ADDENDUM No. 2

**DRAINAGE AND PAVING IMPROVEMENTS
REEDLEY HIGH SCHOOL**

**KINGS CANYON UNIFIED SCHOOL DISTRICT
REEDLEY, CALIFORNIA**

G.A. PROJECT NO. 2219

AD2

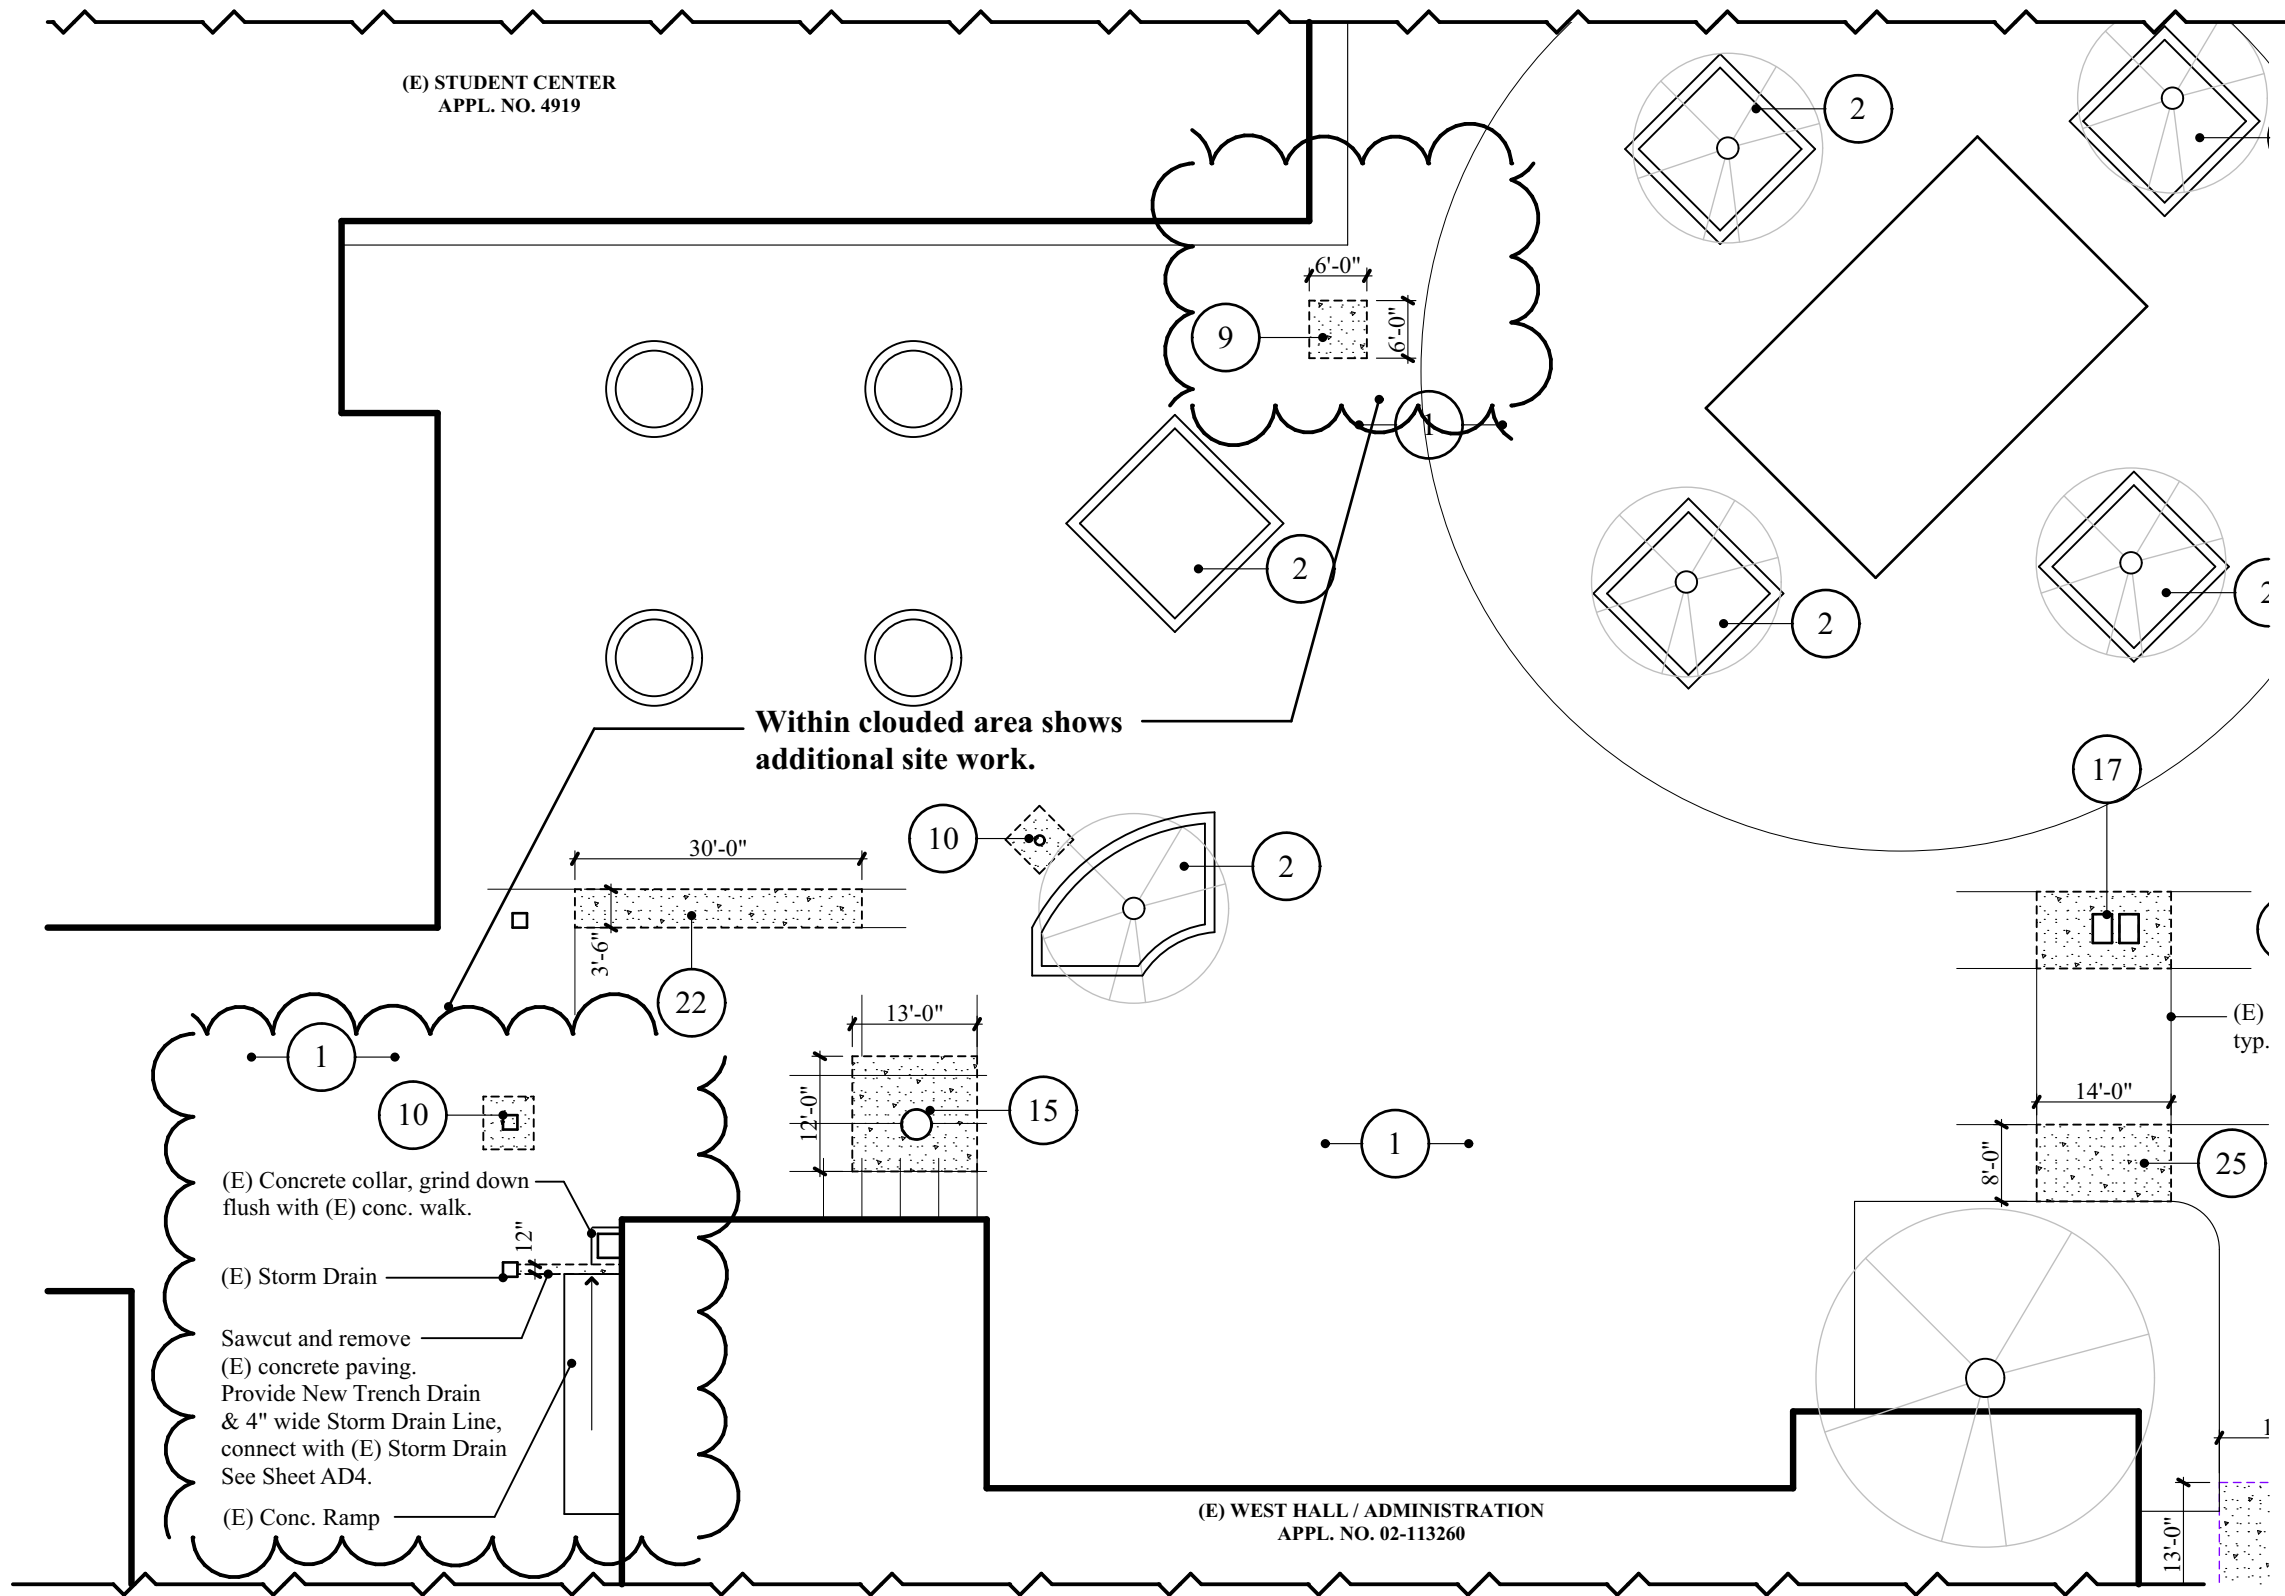
See Sheet AD2, AD3, AD4 and AD5 for additional concrete replacement.
